RE: SSC Cortlandville II LLC and SSC Cortlandville II LLC
Delta Project No.: 2020.260.001 and 2020.261.001

Please accept this letter in response to Mr. Renzi's Comments on Agenda Items memo dated September 29, 2020.

SSC CORTLANDVILLE II LLC

6 VIEW SCREENING PLANTINGS DETAIL (WHEN PLANTED)
CVII-301 SCALE: 1" = 10'

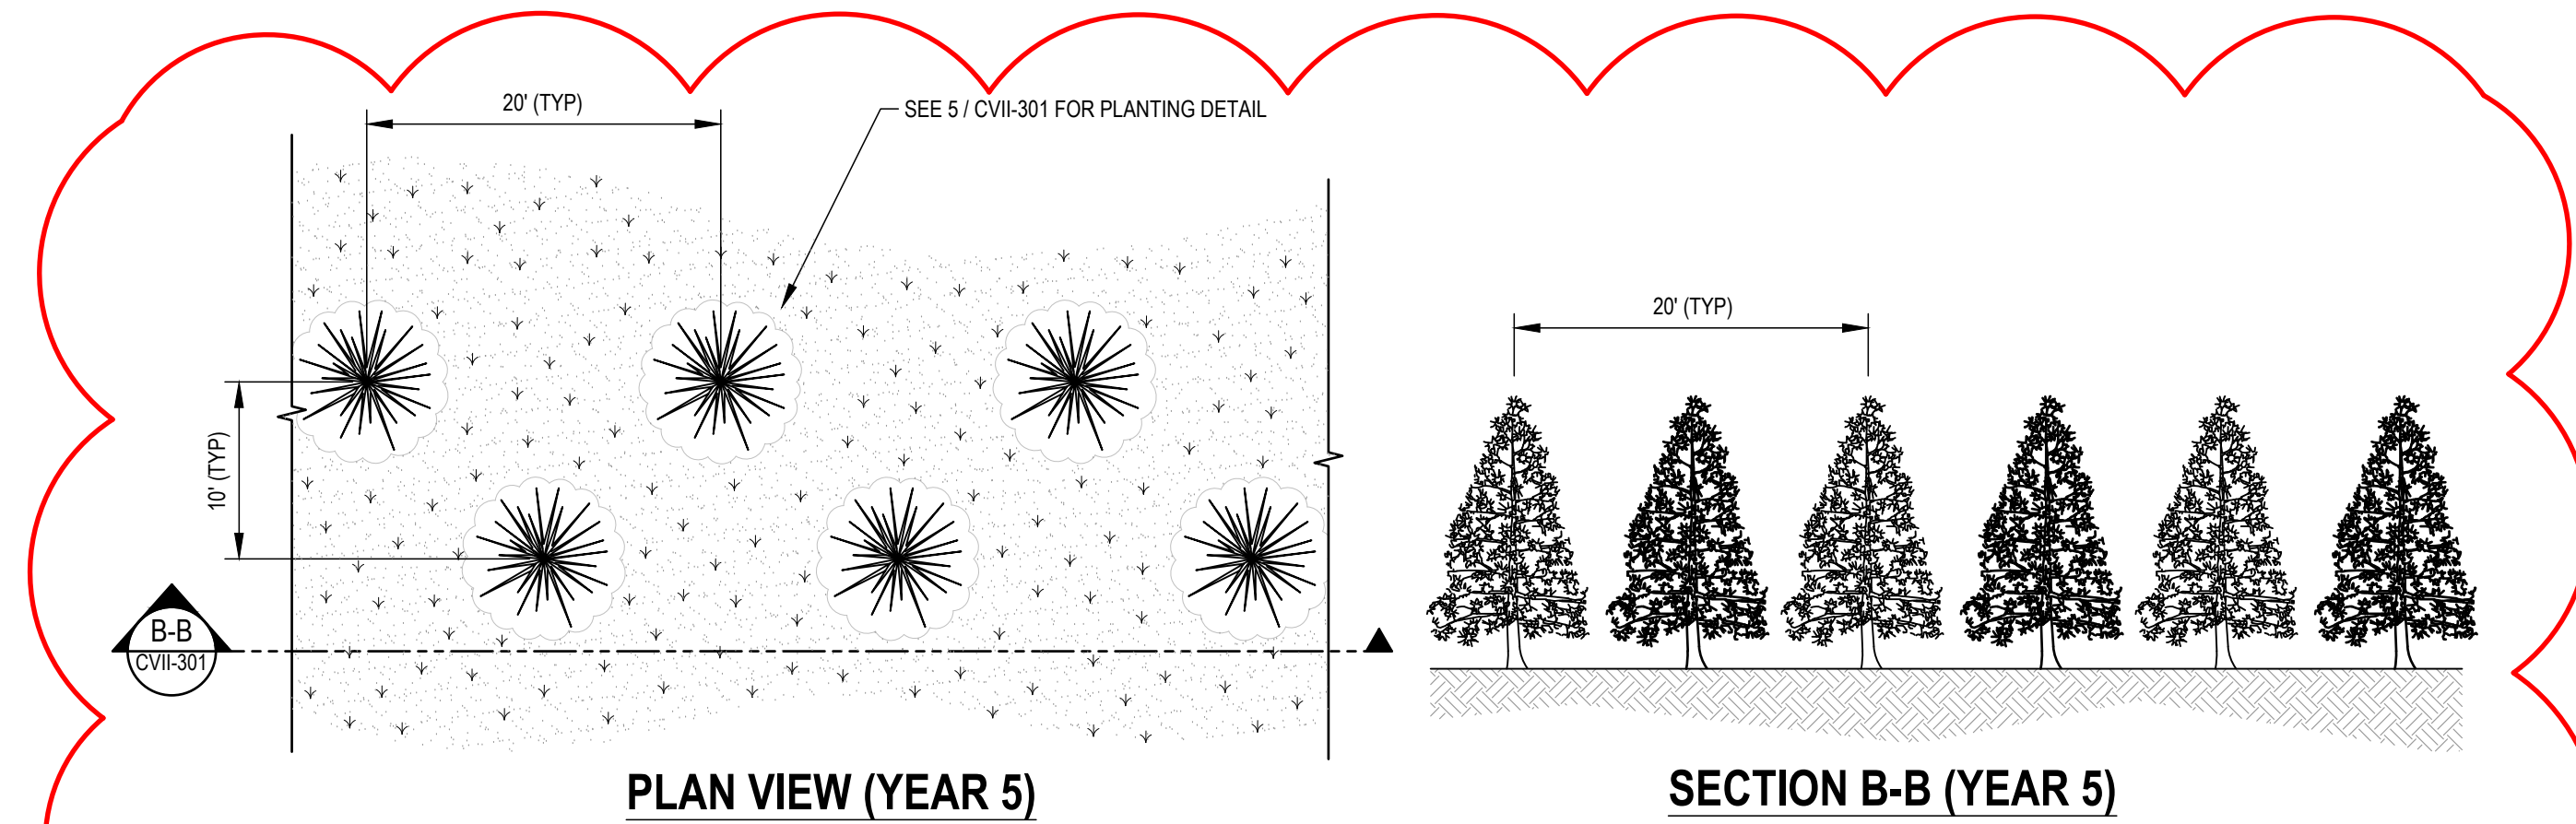
Comment #3: As an example of the aforementioned statement drawing number CVII-301 balloons out in red the view screening plantings detail indicating that the planning board's comments were incorporated, unless addressing the board's comments is tantamount to incorporating their comments. The planning board's comments clearly requested in the August 9, 2020 planning board comments that the in row spacing be ten feet and between row spacing be sixteen feet. The in row and between row spacing is the same as it was on the original submittals.

Comment #4: Still referencing CVII-301 the not to scale drawings are still misleading. Section A-A shows the 20 feet spacing and the trees being also twenty feet. Even though not to scale details are useful they should not be misleading. With screening being an issue in solar farm projects it is incumbent on the applicant to be consistent if even not to scale. The plan view and Section A-A should be redrawn to scale with the spacing requested by the planning board including a height of ten feet for the spruce.

Comment #7 - On Drawings CV11-301 the plan view of the view screening plantings detail references to see 2 / C-303 for planting detail. Drawing C-300 was not in the drawing package.

Response: Applicant acknowledges Mr. Renzis comments. We are appreciative of the suggestion and respectfully request allowing us to keep the row spacing as shown. Our landscape architect

has opined that a decreased row spacing would inhibit growth of the trees due to crowding, causing nutrient deficiencies because of root competition. Branch distribution of the selected species will completely fill in, blocking the viewshed as the trees reach maturity.

Response: The detail on the earlier submissions of this plan set represented the anticipated vegetative growth within a 5-year period which is a typical development practice. An additional detail has been added (Detail 7 Sheet C-301) in this regard. Applicant has additionally revised Detail 6 on Sheet C-301 to represent what the vegetative buffer will look like at the time the trees are planted. We acknowledge the request from Mr. Renzi related to the height of the trees and for the avoidance of doubt we are representing a 15' tree height in Detail 7, consistent with the growth of the species in a 5-year period.

Response: Applicant has provided the drawing in the latest package dated (10.12.20).
